Winning design in our 67th Competition, "Tiki," by B. W. Johns, with Mr. Wm. M. Page, Lic.R.I.B.A., of Wellington

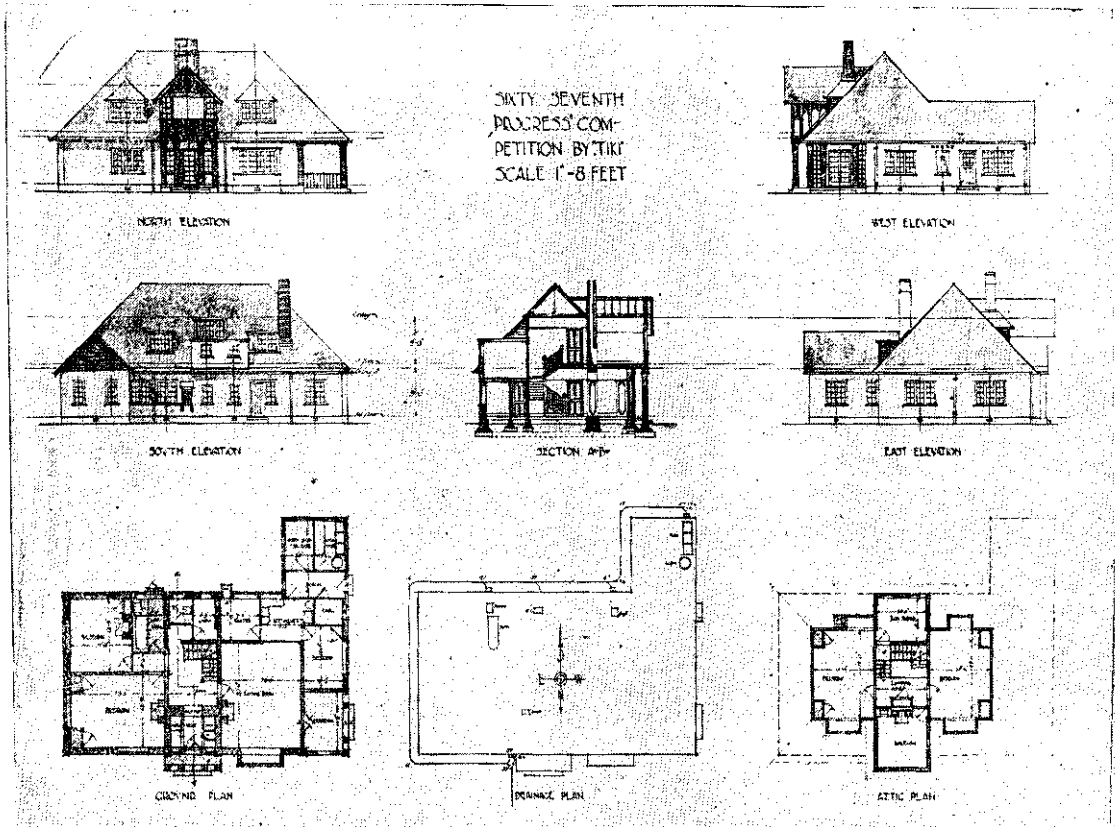
plans. The box room is much larger and higher than necessary, and has completely spoilt the back elevation. There was plenty of space in the roof, without breaking through at all. The sink asked for should have been on the landing, not the balcony. A very careless mistake has been in showing practically all the doors opening the wrong way. It is a universally accepted principle that the bed should be shielded, in place of which 'Tiki' exposes them all. It would be advisable to glaze part of the west side of the verandah, to give protection from the S.W. storms. Finally, the back porch is too wide, 3ft. 6in. being ample, and, in fact, a little ingenuity could have shortened it also. 'Tiki's'

pantry door should be close to the sliding door, or even opening off the living room, for convenience. The partition would be better in brick. The kitchenette would stand being rather larger than the condition suggested. The stair balustrade was meant to be 'close,' i.e., lined up close, with no openings for dust—(another mistake). No. 1 bedroom door is shown opening direct on to the front hall, which is not ideal, and No. 2 bedroom door is hinged so as to expose the bed. (It is advisable to show the position of all beds on the plans.) A 9 feet ceiling is quite high enough. Also the ground floor being raised 3 inches above the ground seems very unnecessary, unless floods are expected. The glazing
